November 4, 1999

**Re: Addendum No. 1 to Removal Action Work Plan -
Upper ½-Mile Reach of the Housatonic River
General Electric Company, Pittsfield, Massachusetts**

This Addendum No. 1 presents information associated with construction and restoration activities in the Upper ½-Mile Reach of Housatonic River adjacent to the Lyman Street Area (as defined in the Consent Decree). This information is presented on two attached figures -- Figure 4-4 and Figure 7-1D. The first figure (Figure 4-4) has been revised to identify the lateral limits of excavation associated with the installation of barrier sheeting at the Lyman Street Area and the location of several removal/restoration cross-sections within the excavation area. In addition, as depicted on Figure 4-4, a continuous layer of rip-rap along the toe-of-slope between polygons SL0229 and SL0170 has been added. The second figure (Figure 7-1D) depicts cross-sections (Sections V-V' through AA-AA') indicated on Figure 4-4 and identifies the limits of excavation and the proposed restoration activities for those areas.

SCALE: HORIZ. 1"=5'
VERT. 1"=5'

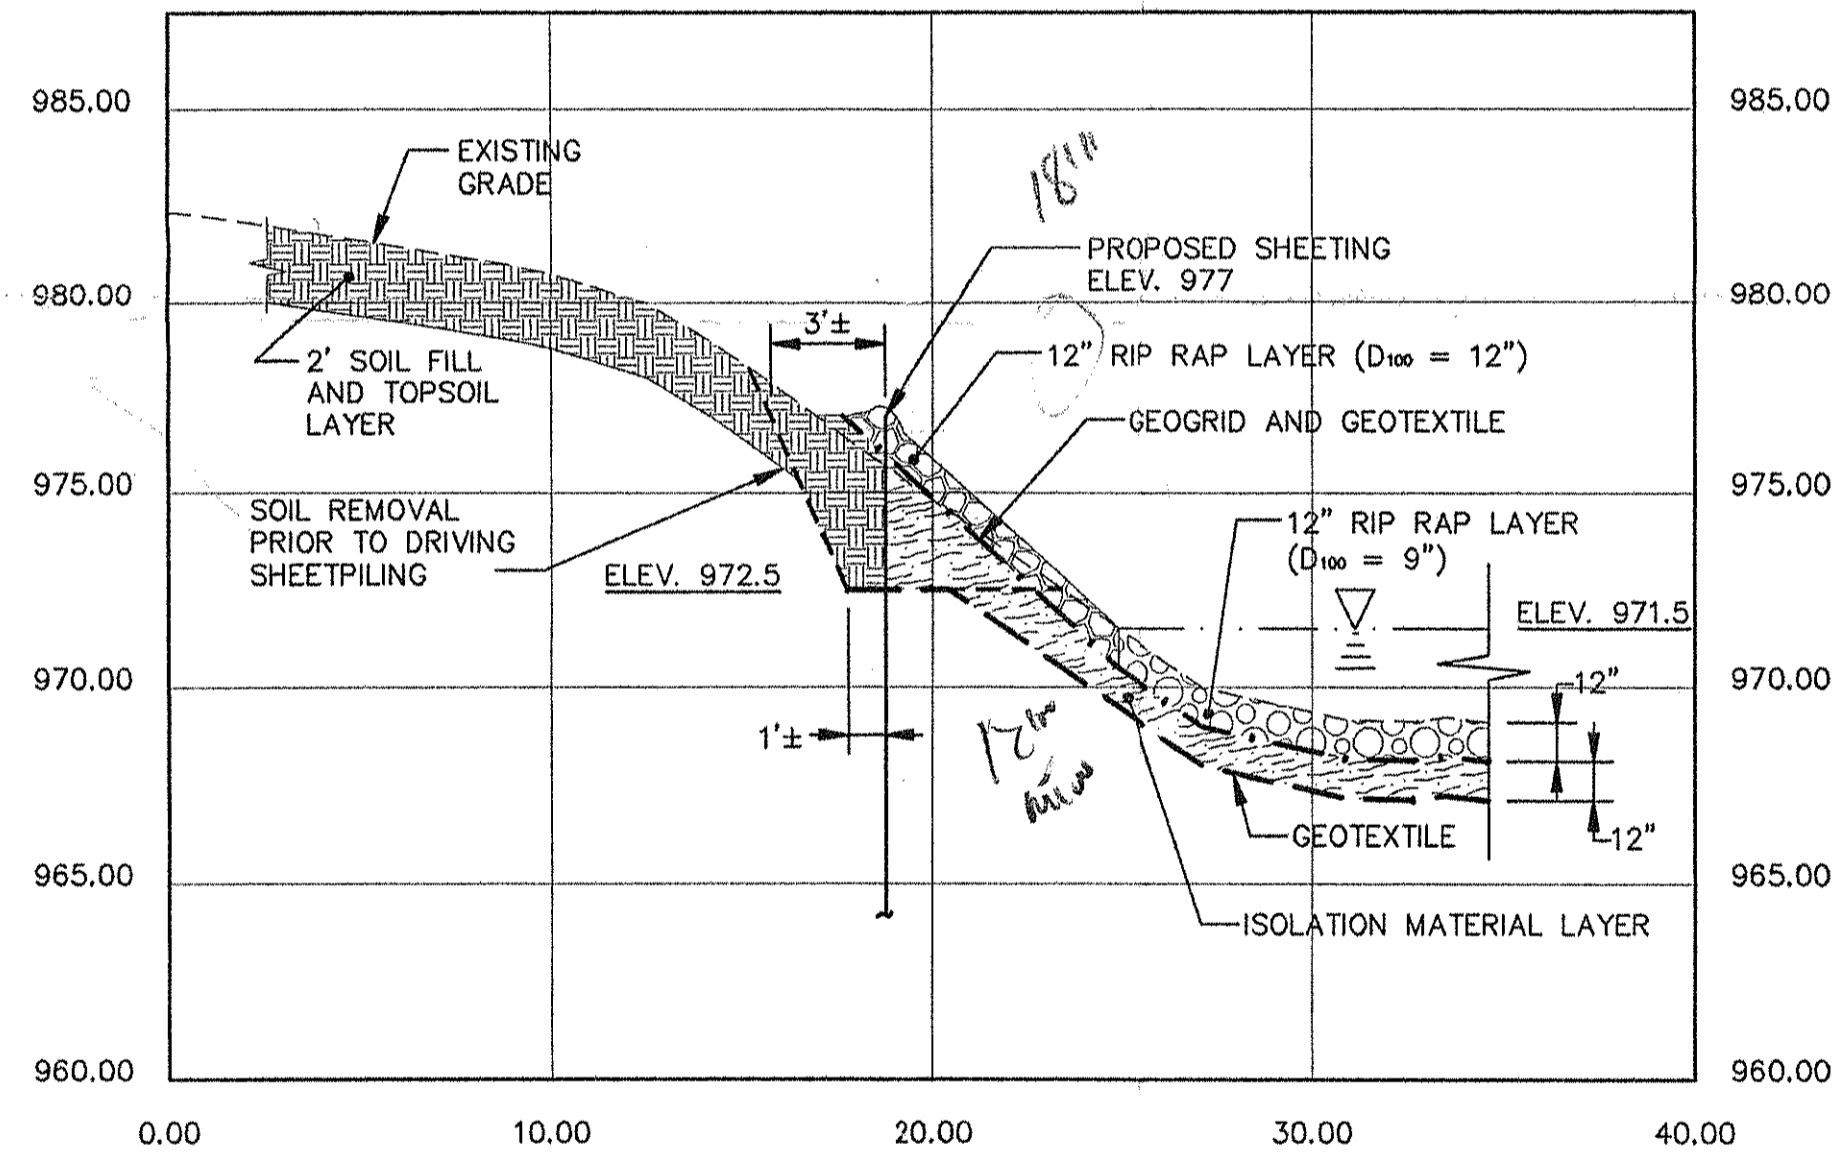
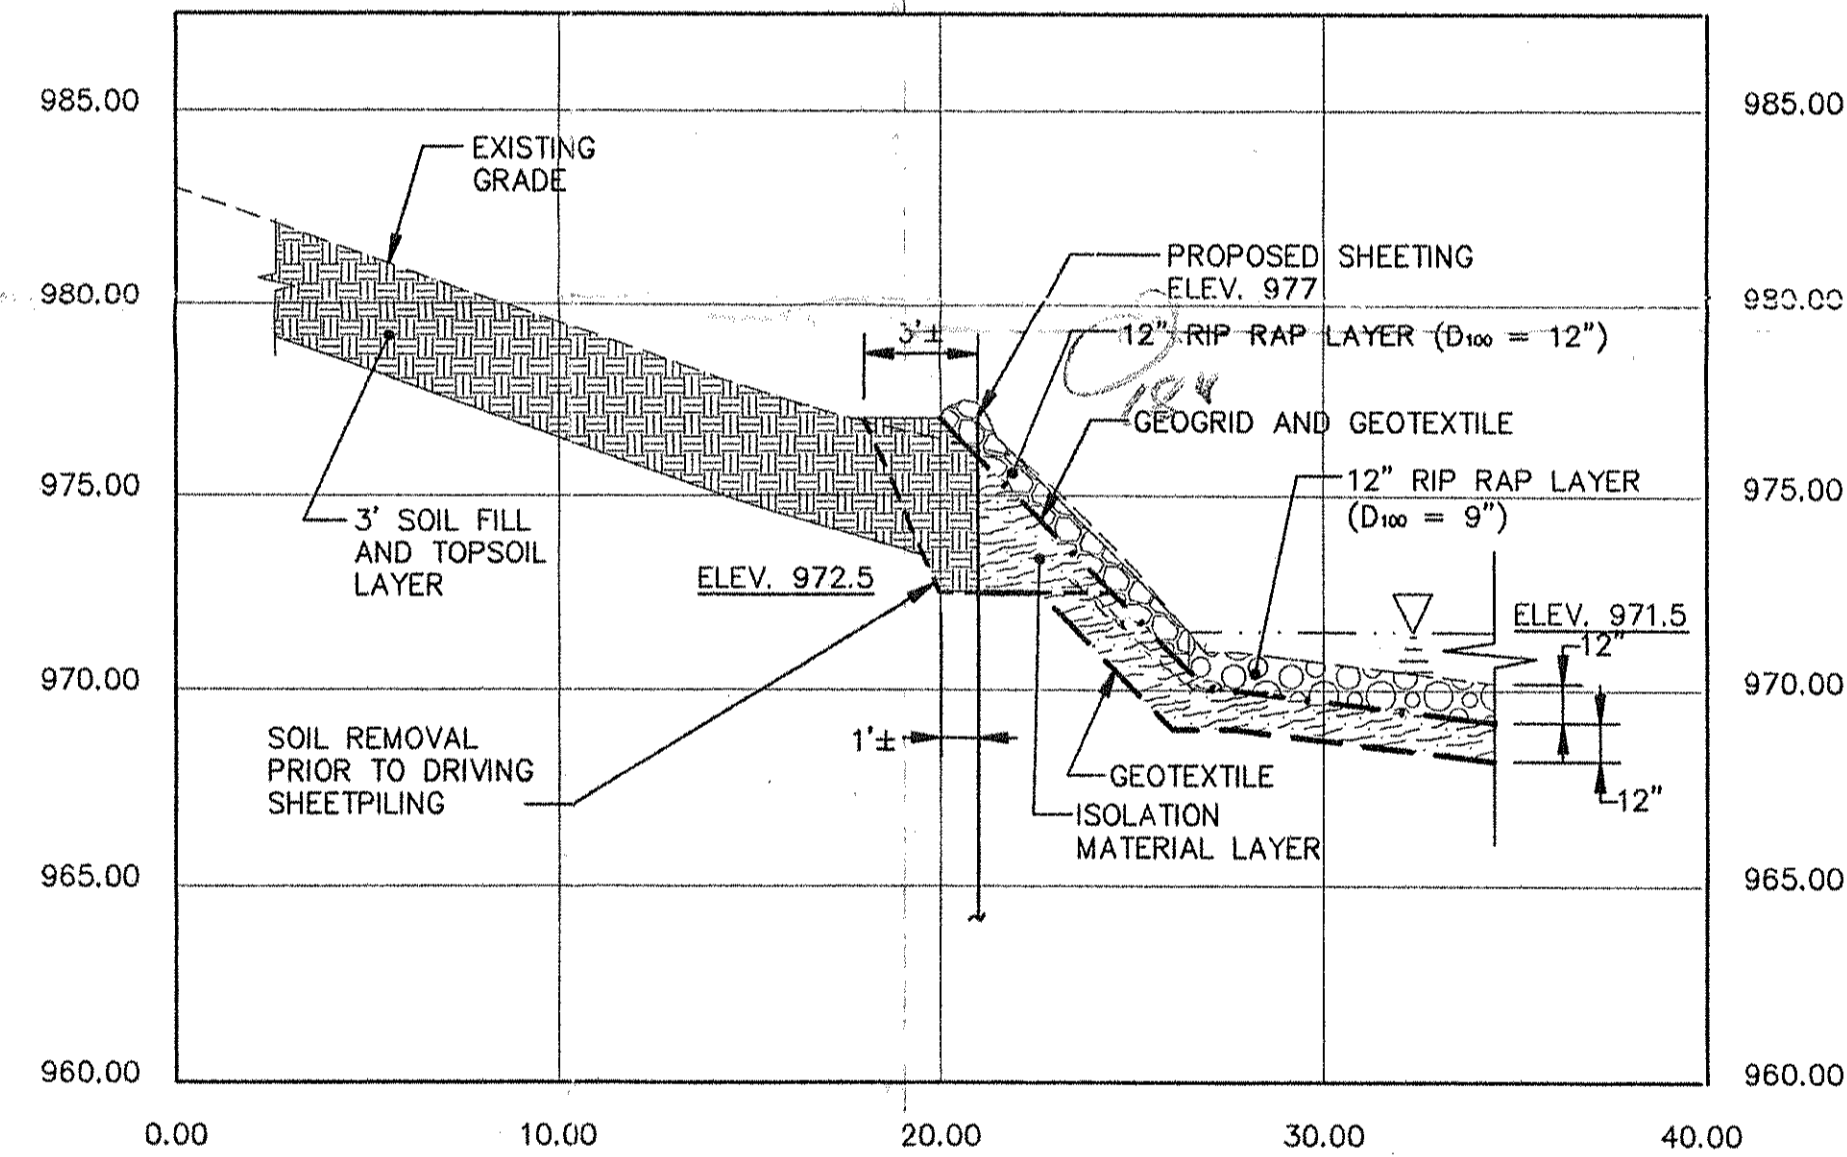
No.	Date	Revisions
1	11/4/99	ADDENDUM No. 1 - SECTIONS V-V' THROUGH AA-AA'

1. THE LOCATION OF THE SHEETPILE SHOWN IS APPROXIMATE AND WILL BE FIELD ADJUSTED BASED ON TOPOGRAPHIC CONDITIONS TO CREATE AN APPROXIMATE SLOPE OF 1H:1V FOR THE RESTORED BANK FROM THE RIVER'S EDGE TO THE TOP OF SHEETING.
